STAFF RECOMMENDATION

413 North 16th Street

May 15, 2013

Application: New Construction—Addition and Outbuilding

Figure 3. The garage will be accessed via an existing front driveway.

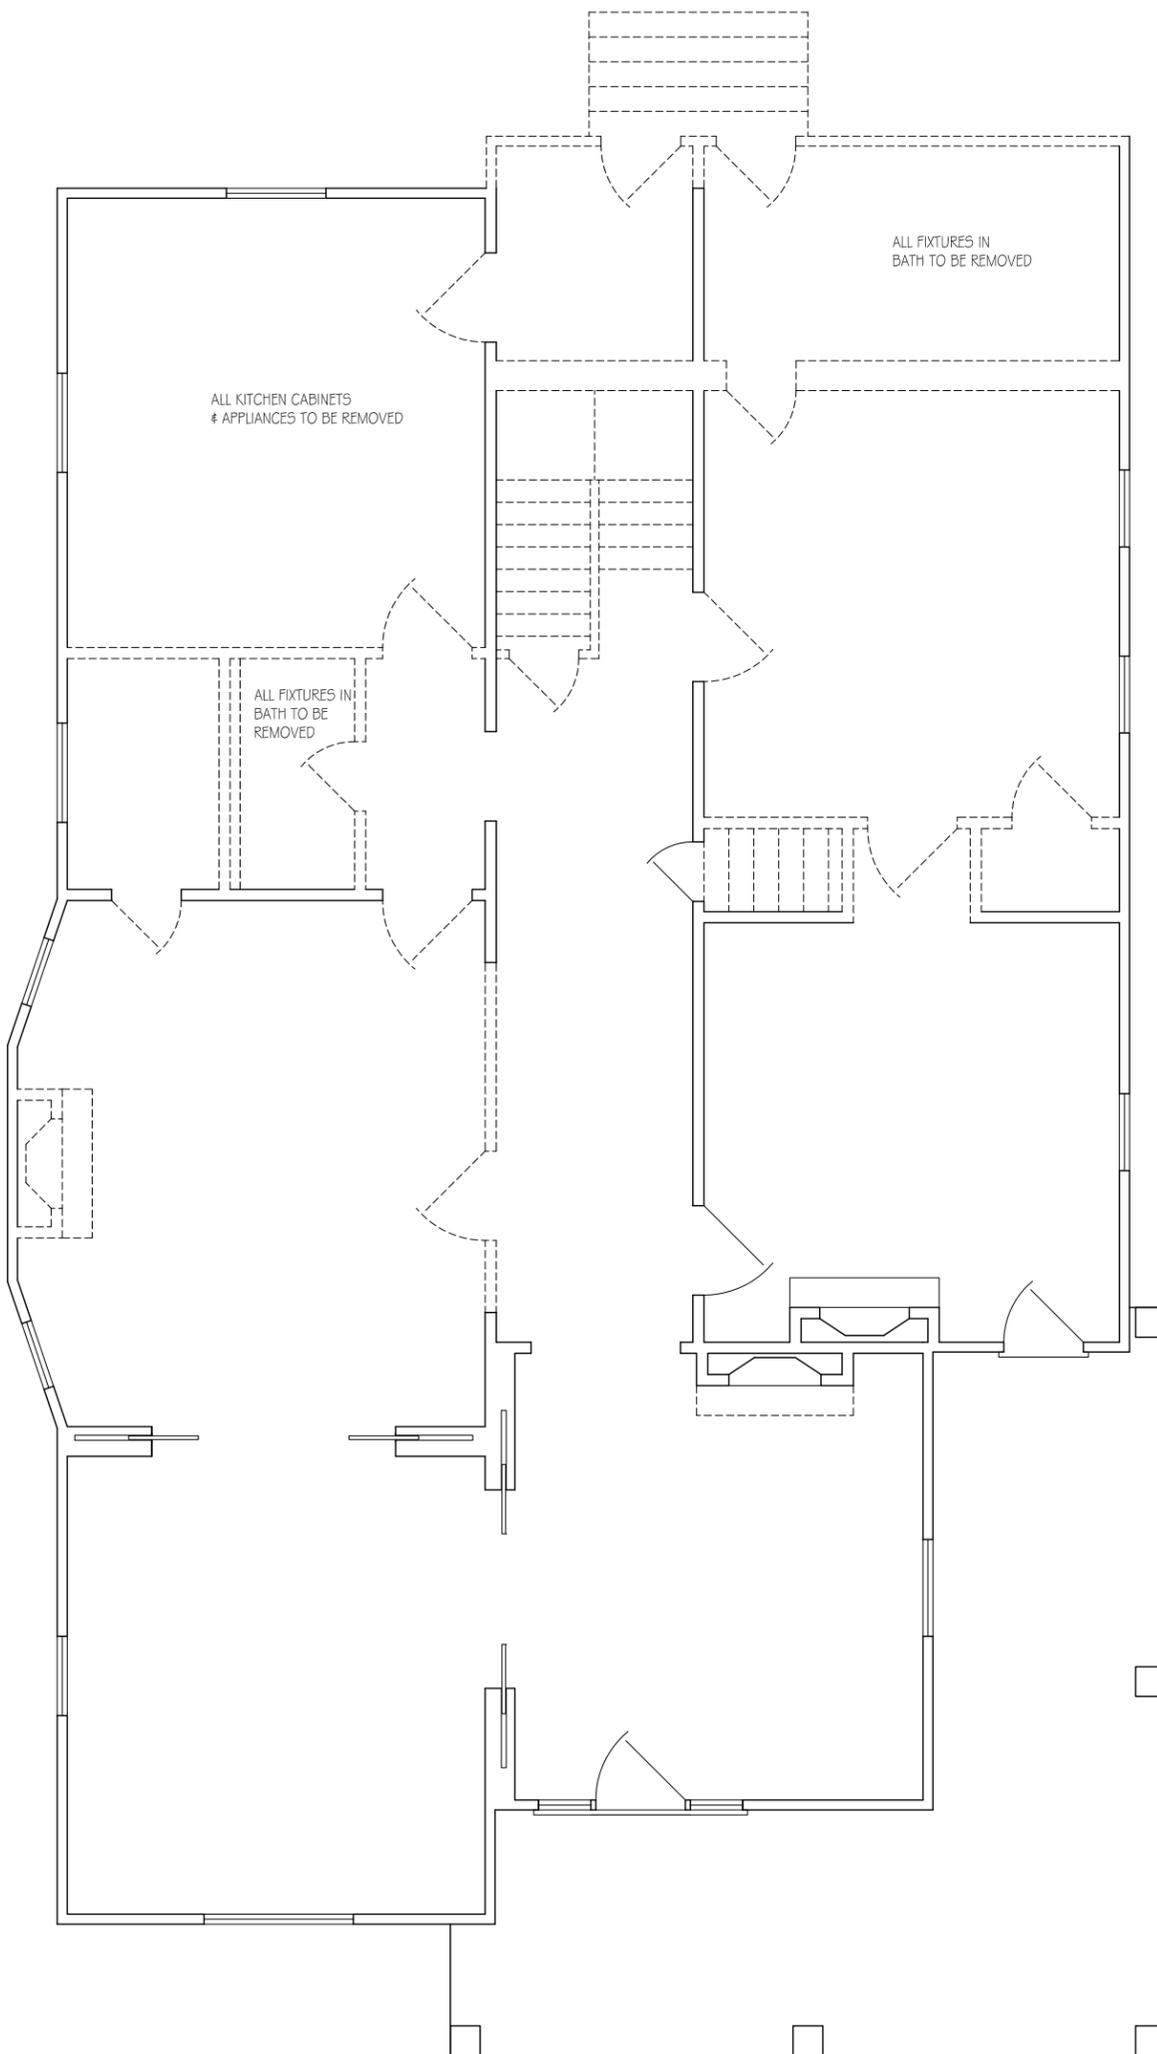
Outbuilding: The outbuilding will be placed at the rear of the property and will be accessed via an existing driveway since the property does not have alley access (See Figure 3). The outbuilding meets all base zoning requirements for setbacks. It is three feet, five inches (3'5") from the left property line at its narrowest point, is five feet, three inches (5'3") from the rear property line, and more than twenty feet (20') from the right side property line. The outbuilding will be oriented so that its garage doors face the right/south side of the property. The structure will be twenty-five feet (25') wide and twenty-two feet (22') deep. It will have an eave height of approximately eleven feet (11'), and a ridge height of nineteen feet, nine inches (19'9"). The roof will be gabled with a slope of 8/12. The window and door openings are appropriate for an outbuilding. The cladding will be cement fiberboard or wood siding. The materials for the roof, doors, and windows were not specified and staff asks to approve these materials prior to purchase and installation. Staff finds that the outbuilding meets Section II.B.8. of the *Lockeland Spring-East End Neighborhood Conservation Zoning Overlay: Handbook and Design Guidelines*

FOUNDATION PLAN

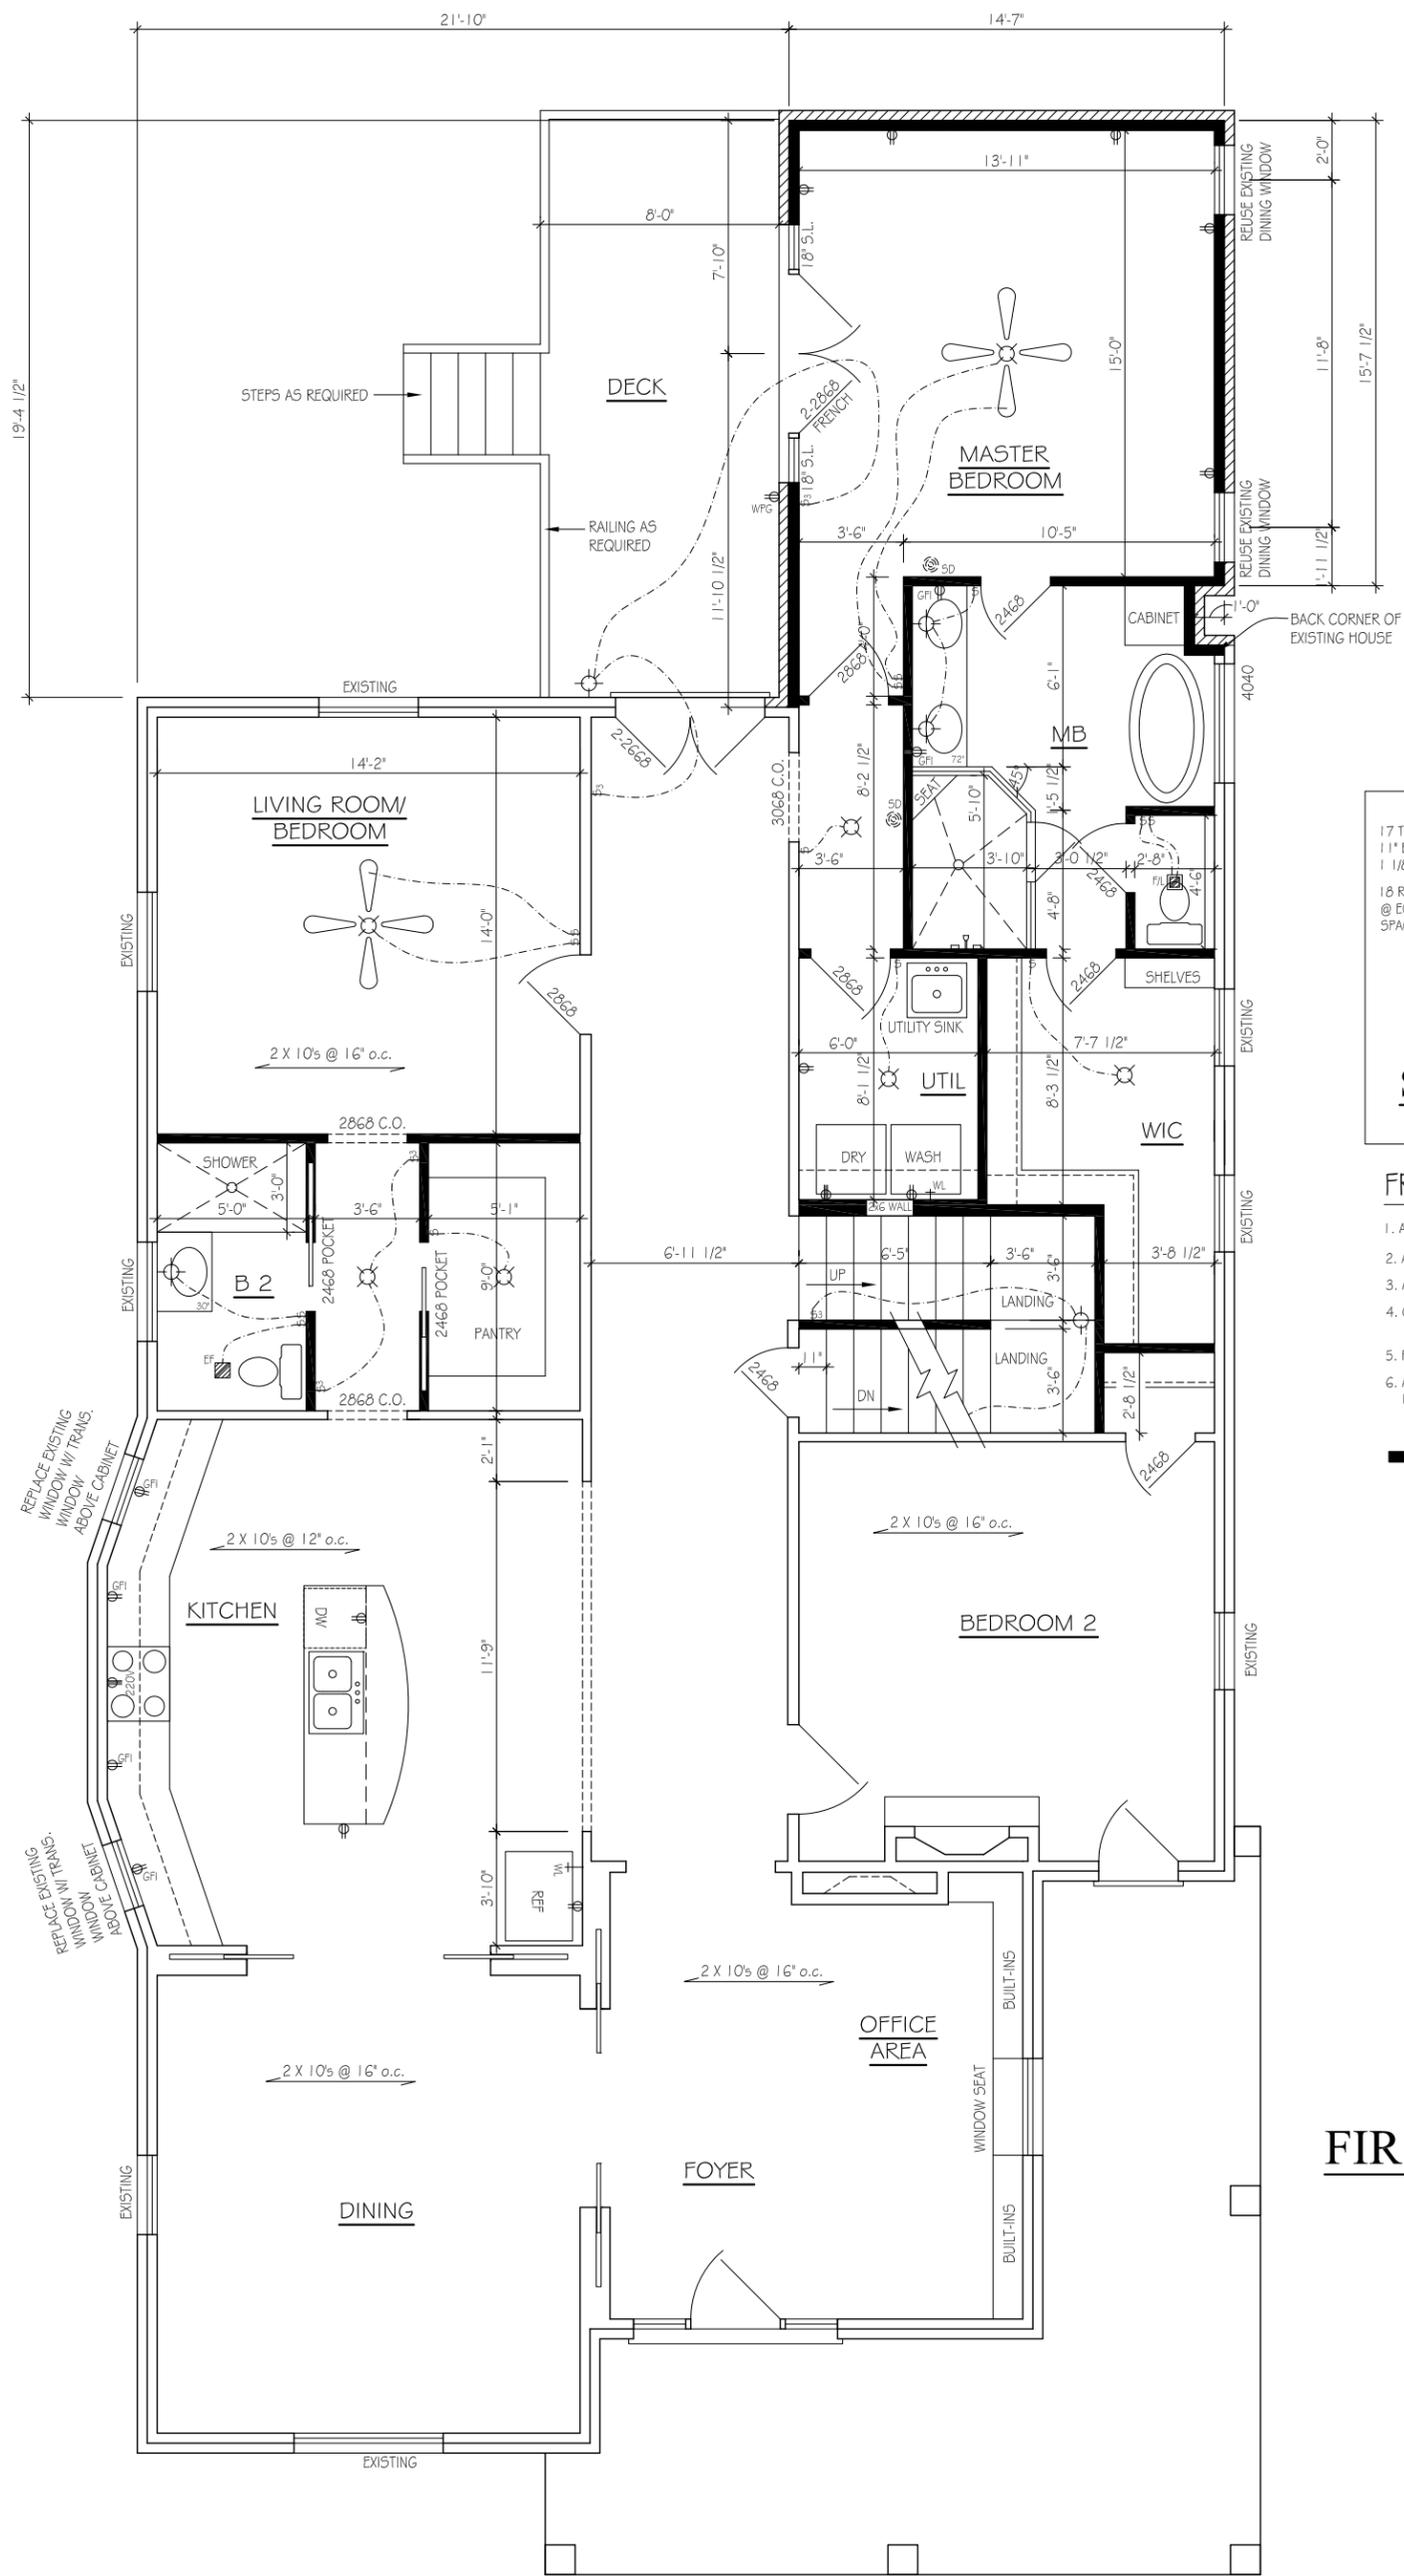
Rear Addition: The rear addition will be one story in height and will be inset one foot (1') from the back wall of the house for a depth of one foot (1'). After the inset, the addition steps back out to match the line of the house. The addition will be approximately fifteen feet, seven inches (15'7") deep, and fourteen feet, seven inches (14'7") wide. The addition's eave height will match that of the house, and its ridge height will be approximately twenty feet (20') or seven feet (7') below the ridge of the house. The addition will be constructed of brick and will be painted to match the house. The material of the foundation was not specified, and staff asks that the foundation line match

that of the house and that the new foundation either match the foundation material of the house or be split face concrete block. Staff asks to also approve the asphalt shingle color if it does not match that of the house and all window and door specifications. The addition's windows are generally twice as tall as they are wide and there are no large expanses of wall space without a door or window opening. The addition's roof will be hipped and will have a roof slope to match that of the house.

1. The foundation line for the addition match that of the house and the foundation material match that of the house or be split face concrete block.
2. Staff review and approve the shingle color and the window and door materials and specifications prior to purchase and installation.

LEFT SIDE ELEVATION

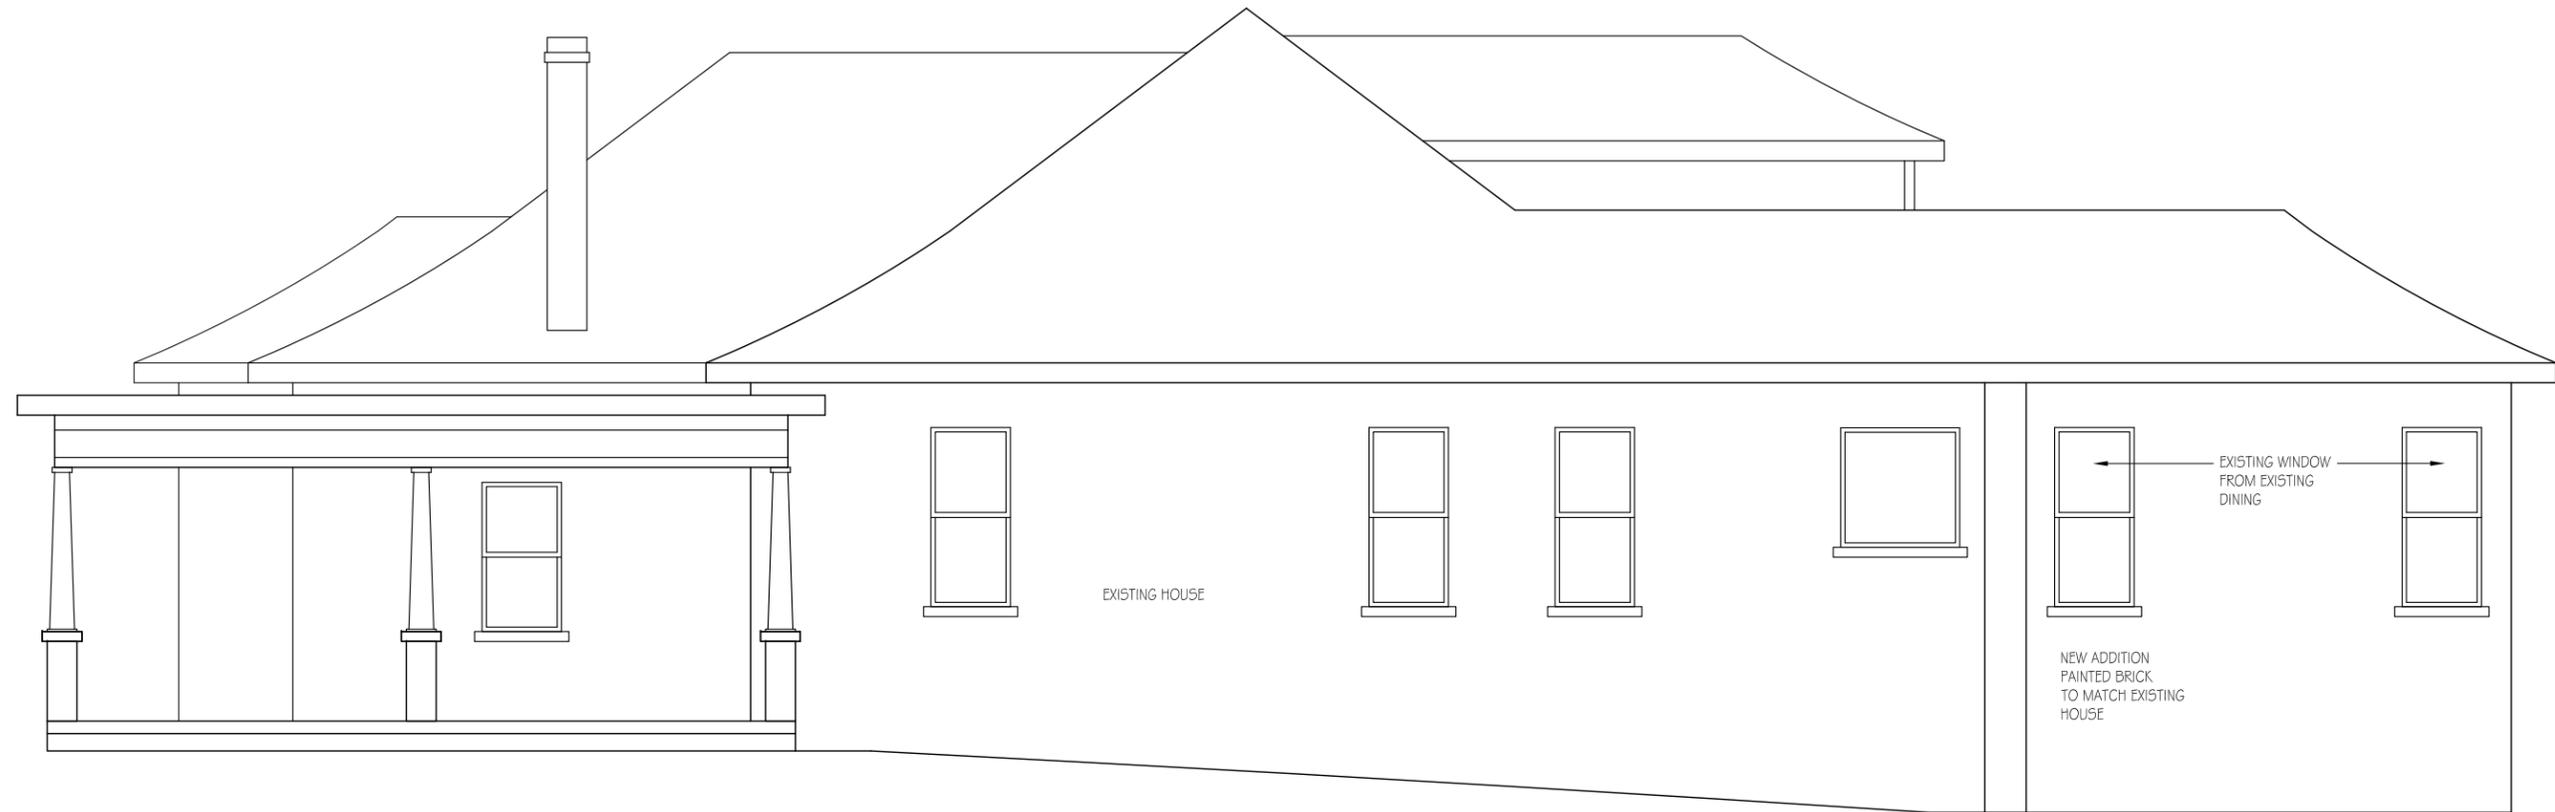
Side Dormers: Two side dormers are proposed for the left side of the roof, which is the less visible of the two side roofs (see Figure 2). Staff finds that the dormers size and location are appropriate to the style and design of the historic structure. The dormers will each be four feet, eight inches (4'8") wide and six feet, eight inches (6'8") tall. The dormers will have hipped roofs that will match the roof slope of the house, and the dormer's eave depth will match that of the house. The dormers will be at least two feet (2') off the ridge of the roof and two feet (2') off of the house's sidewall. The dormers will be clad in cement fiberboard or wood siding. Staff finds that the dormers meet Sections II.B.2., II.B.5., and II.B.10. of the *Lockeland Spring-East End Neighborhood Conservation Zoning Overlay: Handbook and Design Guidelines*.
